Title Response to ECC A120/A133 Link Road & Rapid Transit System

Consultation

Colchester Borough Council response to A120/A133 Link Road Consultation

<u>Colchester Borough Council response to North Essex Rapid Transit System Stage 1 Options</u> Technical Note

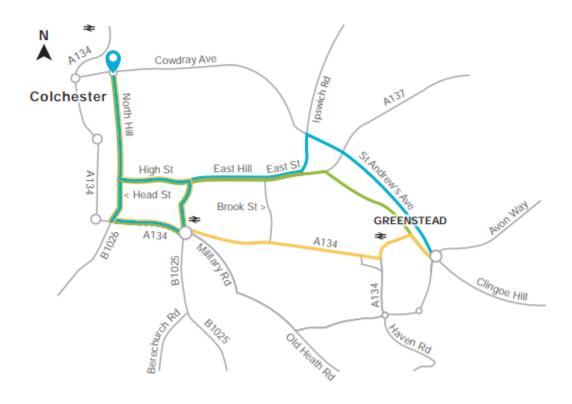
Option 1A does not significantly encroach on to the Garden Communities developable area. Its location could form the eastern boundary to the potential residential area.

In terms of negative impacts, Option 1A adversely affects the Strawberry Grove wooded area, routed through the middle of the wood and therefore resulting in the loss of woodland. It would also impact on properties in the area including the Grade II Listed Allen's farmhouse.

Option 1C is the most easterly route and therefore would not encroach on to the Garden Communities developable area. Its location could therefore form the eastern boundary to the potential residential area. This is also the shortest route and no land is required from the A120 services or the Waste Transfer Station.

In terms of negative impacts, the proposed slip roads as shown would negatively impact on Strawberry Grove wooded area, removing existing connectivity between the woodland and the natural landscape with potential loss of some woodland. The slip roads as shown appear excessively long. It is considered that this junction arrangement could be reconsidered to assess the potential for the slip roads to be closer to the A120, which although may result in the loss of some of the Strawberry Grove wooded area, would mean that it was not enclosed by roads.

Option 1D is the most westerly of the Option 1 routes and is the longer option. It avoids the areas of woodland, apart from the top corner of the Strawberry Grove wooded area and is further away from the Listed Building.

In terms of negative impacts, the route is further west and therefore has potential to impact on the proposed Garden Community developable area.

The northern section of Option 3 runs further westwards than Option 1. The new junction would utilise the existing location of the Bromley Road overbridge, which would be removed and replaced on a different alignment close by. In terms of the relationship to the Garden Community Option 3 is likely to encroach on to the developable area.

In terms of negative impacts Option 3 requires the closure of the existing slip roads to the Waste Transfer Station and traffic may therefore be required to use the local road network. The route also passes close to existing properties and may cause significant impacts on residential amenity. The route would also impact on the Public Right of Way network.

Two locations are proposed for Options 1 and 3 for the junction of the Link Road with the A133. The eastern option would link with Elmstead Road (south of the A133). The second location is slightly to the west of this option. No detail is provided on the impact the two different locations may have on travel patterns. It is considered that further information is required to understand the impact on the local road network. In particular, the eastern option may result in additional traffic on Elmstead Road south of the A133 and therefore CBC would like to see further detail on the potential increase

in traffic on Elmstead Road for this option, and mitigation measures that could be undertaken, prior to a decision being made. The Borough Council would wish to continue the close working and dialogue with the County Council, to further understand the impact on the local road network, particularly on Elmstead Road and links into Wivenhoe, before a decision is made on the location of the junction of the Link Road with the A133.

In conclusion CBC consider Option 1 as preferable in terms of its ability to meet the objectives. It is considered that Option 1C may be preferable in terms of it being the most easterly proposed layout. However, it is felt that the design of the slip roads in this option are currently too long and result in the area of woodland being left isolated. If this option is taken forward, consideration should be given to redesigning the slip roads to overcome this. CBC considers that continued close liaison with the North Essex Authorities is important to ensure that the road is designed in line with the Masterplan and design principles for the proposed Garden Community, to ensure an appropriate relationship between the road and the future community.

Appendix B: RTS Route Options (Extract from consultation document)

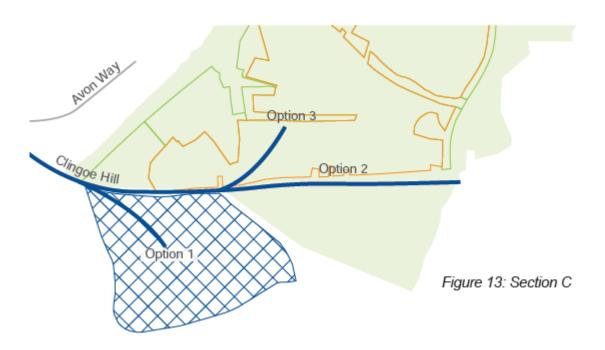
Option 1 provides a relatively direct route from Middleborough to Greenstead Roundabout. CBC notes the concerns as to the operation of an RTS which would be in conflict with the level crossing at the Hythe and could result in reliability issues for the RTS. However, it may be that these issues could be overcome, and it is considered that this should be explored before this option is ruled out. In addition to the level crossing conflict CBC also has concerns that Option 1 would require substantial removal of on street parking along Magdalen Street. Any reallocation of road space will have to be carried out in consultation with affected residents and businesses.

Option 2 also provides a direct route from Middleborough to Greenstead Roundabout albeit with the same concerns as those highlighted in respect of Option 1, above. CBC also notes that the conflict with the East Gates level crossing is more severe than Option 1's conflict with the Hythe level crossing due to the additional train services which run along this section of the railway. As above, it is considered that it may be that it may be that these issues could be overcome and this should be explored before this option is ruled out. Again, CBC has concerns that Option 2 would require substantial changes to the road layout including the removal of on street parking. Any proposed changes to existing uses along the route should therefore be carried out in consultation with affected residents and businesses.

Option 5 runs along the same route as Option 2 but importantly it removes the conflict with the East Gates level crossing by routing up Ipswich Road over the railway bridge. CBC notes that St Andrew's Avenue has benefits as an RTS option due to its relatively wide highway area. However CBC has concerns that the road forms part of the Avenue of Remembrance with extensive tree planting along its sides, the vast majority of which are protected by Tree Protection Order.

From a landscape perspective if Option 5 is taken forward, it would need to be carefully considered as, in addition to the potential loss of an important avenue of trees it may also compromise the setting of the Avenue of Remembrance in other ways, e.g. potential loss of deep grassed verges which form part of the Avenue as the historic setting for the trees.

CBC recognises the University of Essex as a major stakeholder in both the RTS and the Garden Community and the integration of both with the University will be essential to the future success of the projects. CBC therefore supports the consideration of this option and more widely the RTS utilising roads within the grounds of the University in accordance with any future agreement with the University.

From a landscape perspective Option 1 needs to be carefully considered, as it may have a visual/landscape impact on the Grade II listed Wivenhoe Park. Also, it would potentially involve the loss (breaching) of a number of sections of hedgerows protected by the Hedgerows Regulations 1997 (HR97) to facilitate construction of the link from the University to the B1027. It is recommended that under Appendix K, the Environmental Risk Assessment, when submitted, be informed by a Townscape/Landscape & Visual Impact Assessment, Arboricultural Impact Assessment and HR97 surveys (the latter will need to be undertaken by the LPA (i.e. CBC).

CBC considers that this option entails a direct route from the Garden Community to Greenstead Roundabout (without diversion through the University) which offers benefits to the journey times of the RTS. However, CBC recognises that there will need to be careful consideration about the road layout at Clingoe Hill to ensure that congestion is properly managed.

CBC notes that this route is the most direct and therefore will offer the most benefits to RTS journey times however it would also reduce the potential to integrate the RTS with the University which as a significant destination in the area and would warrant a stop on the system. CBC would therefore only support Option 3 if such integration can take place.

Consideration of the access point should take into account potential for land earmarked for other purposes such as future country park along the Salary Brook corridor as it is likely that these two land uses would be incompatible.

As with Option 2 there will need to be careful consideration about the road layout at Clingoe Hill to ensure that congestion is properly managed and that the RTS does not conflict with other traffic.
